PRODUCT CHANGE NOTIFICATION

SURGE PROTECTIVE DEVICES

Bourns® Model 1250A and 1420A Series Surge Protective Device (SPD) Marking Process *Change from Laser Etching to Ink Marking*

OSP2312

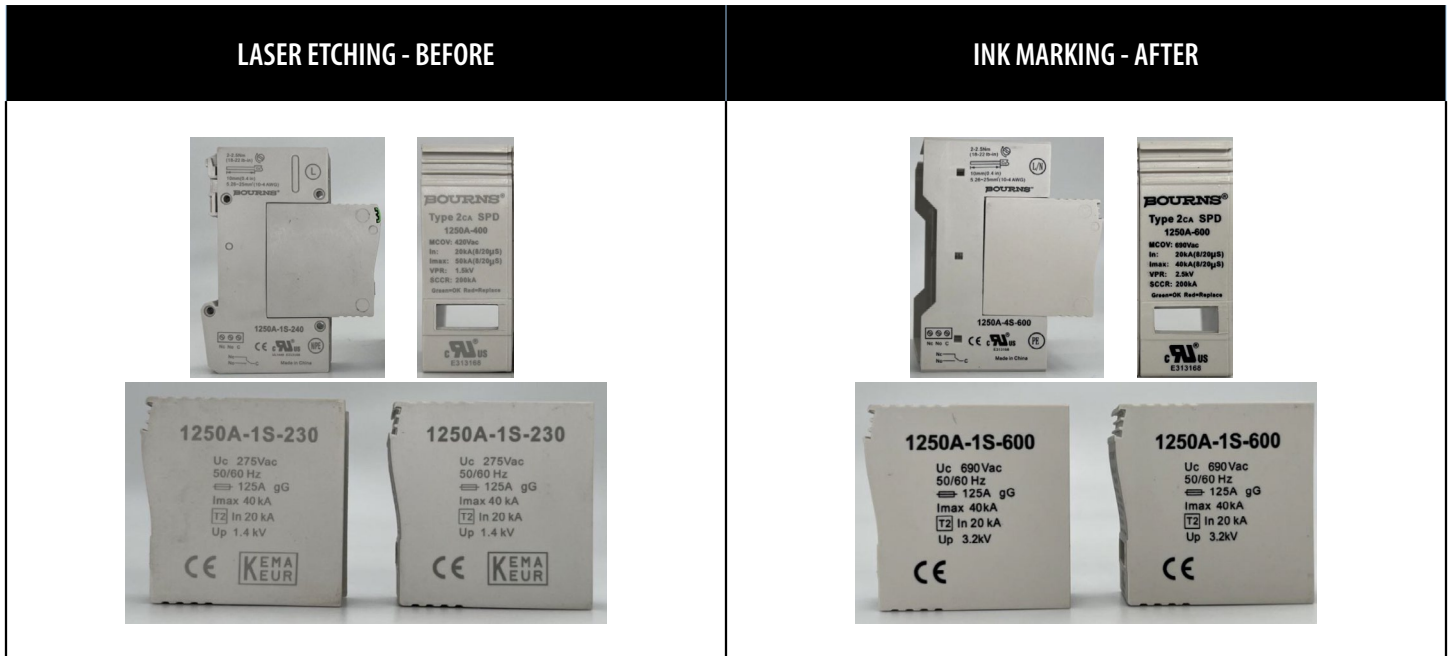
Riverside, California – September 19, 2023 – In the spirit of continuous improvement, effective November 1, 2023, Bourns will change the marking process for the [Model 1250A Series General Duty AC SPD](#) and [Model 1420A Series DC Power SPD for Photovoltaic Applications](#) from laser etching to ink marking. The print quality of the laser etching is not clear on curved surfaces. Shifting to the ink marking process will optimize efficiency, reduce losses, and maintain clear markings. A list of affected part numbers is provided below.

The change in printing method will have no effect on the fit or function of the product. The form of the product and the manufacturing process will change due to the difference in appearance and use of a different marking process step. The quality and reliability of the marking on the products should be improved as a result of the process change. There are no changes to the data sheet ratings, electrical/packing characteristics or the manufacturing site. Samples using the new marking process are available upon request.

Date that manufacturing of existing products will cease: **November 1, 2023**

Date that deliveries of modified products will begin: **November 2, 2023**

First date codes: **2344**
